# Access Compliance Report

## Public Rights-of-Way

Intersection ID: 10199	Main Street: CALTON_LN	Cross Street: TUCKASEEGEE_RD	Location: W
ADA ID: 2F4D1D56C6C2	Ramp Type: Perp	Initial Pass/Fail: Fail	Overall Compliance: No
		Severity Score: 12.5

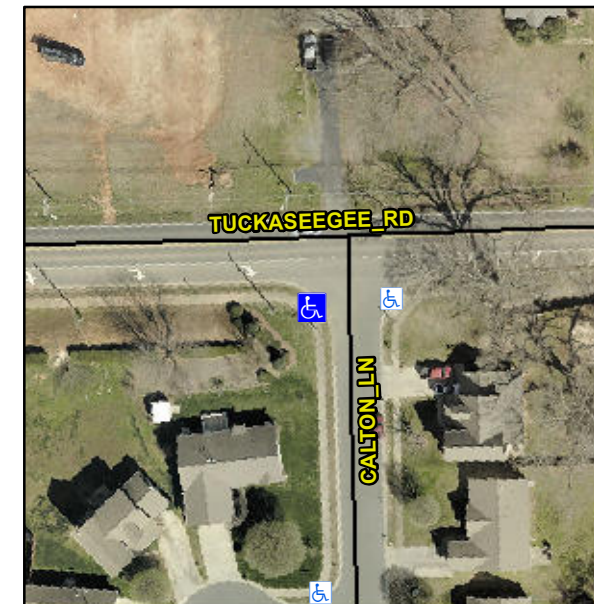
**Not Found, R304.2.2**

Compliance	Description	Data	Compliance	Description	Data
N/A	Ramp Length (in)	50.0	No	Ramp Slope (%)	8.7
Yes	Ramp Width (in)	53.0	Yes	Ramp XSlope (%)	0.0
N/A	Flare Type LT	N/A	N/A	Flare Type RT	N/A
N/A	Flare Slope LT (%)	N/A	N/A	Flare Slope RT (%)	N/A
N/A	Flare Traversable LT?	N/A	N/A	Flare Traversable RT?	N/A
N/A	Landing Length (in)	N/A	N/A	DWS Provided?	N/A
N/A	Landing Width (in)	N/A	N/A	DWS Contrast?	N/A
N/A	Landing Slope (%)	N/A	N/A	DWS Length (in)	N/A
N/A	Landing X Slope (%)	N/A	N/A	DWS Full Width?	N/A
N/A	Landing Curb? (Y/N)	N/A	N/A	DWS Offset (in)	N/A
N/A	Shared Landing?	N/A			
N/A	Gutter Ponding?	N/A	N/A	Gutter Slope (%)	N/A
N/A	Gutter Lip Ht (in)	0.5	N/A	Gutter X Slope (%)	N/A
N/A	Painted X Walk1?	No	N/A	Painted X Walk2?	N/A
	X Walk 1 Direction	To E		X Walk 2 Direction	N/A
N/A	X Walk 1 Width (in)	N/A	N/A	X Walk 2 Width (in)	N/A
	X Walk 1 Slope (%)	0.0		X Walk 2 Slope (%)	N/A
	X Walk 1 X Slope (%)	1.1		X Walk 2 X Slope (%)	N/A

**Remove & Replace Entire Ramp.**
